CONSTRUCTION DRAWINGS STONEBRIDGE FILING 4 AT MERIDIAN RANCH

IMPROVEMENT PLANS PREPARED FOR GTL, INC. DBA GTL DEVELOPMENT, INC.

SF-18-023

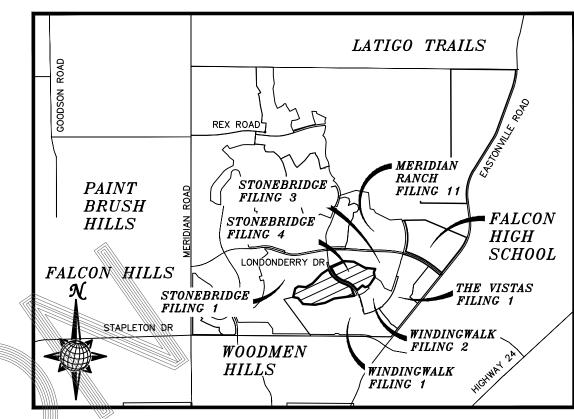
Daniel Torres (3) Subject: Callout SF-18-023 Page Label: [1] 01 COVER SHEET Author: Daniel Torres Date: 8/16/2018 10:26:14 AM Color: Subject: Callout **PCD** Page Label: [1] 02 INDEX SHEET **Author:** Daniel Torres Date: 8/16/2018 9:35:57 AM OR SHALL COORDINATE GEOTECHNICAL TESTII Y EL PASO COUNTY PCD PRIOR TO PLACEME Color: Subject: Callout El Paso County Department of Public Works Page Label: [1] 02 INDEX SHEET Author: Daniel Torres Date: 8/20/2018 7:41:28 AM Color: Subject: Re: Callout Change comment to Department of Public Works Page Label: [1] 02 INDEX SHEET (DPW) Author: dsdlaforce Date: 8/17/2018 10:59:19 AM Color: dsdlaforce (5) Subject: Callout Identify the dep Page Label: [1] 07 GRANITE RIDGE DR. Author: dsdlaforce Date: 8/20/2018 8:32:39 AM Color: Subject: Callout Provide a slope label Page Label: [1] 09 GRANITE RIDGE DR. & GRANITE PARK LN. Author: dsdlaforce Date: 8/20/2018 8:54:07 AM Color: Subject: Callout Revise. Per ECM Figure 2-31 (pg 2-62), the Page Label: [1] 12 MERIDIAN HILLS TR. maximum grade in the cul-de-sac bulb is 3 percent Author: dsdlaforce Date: 8/20/2018 8:57:23 AM Color: Subject: Callout
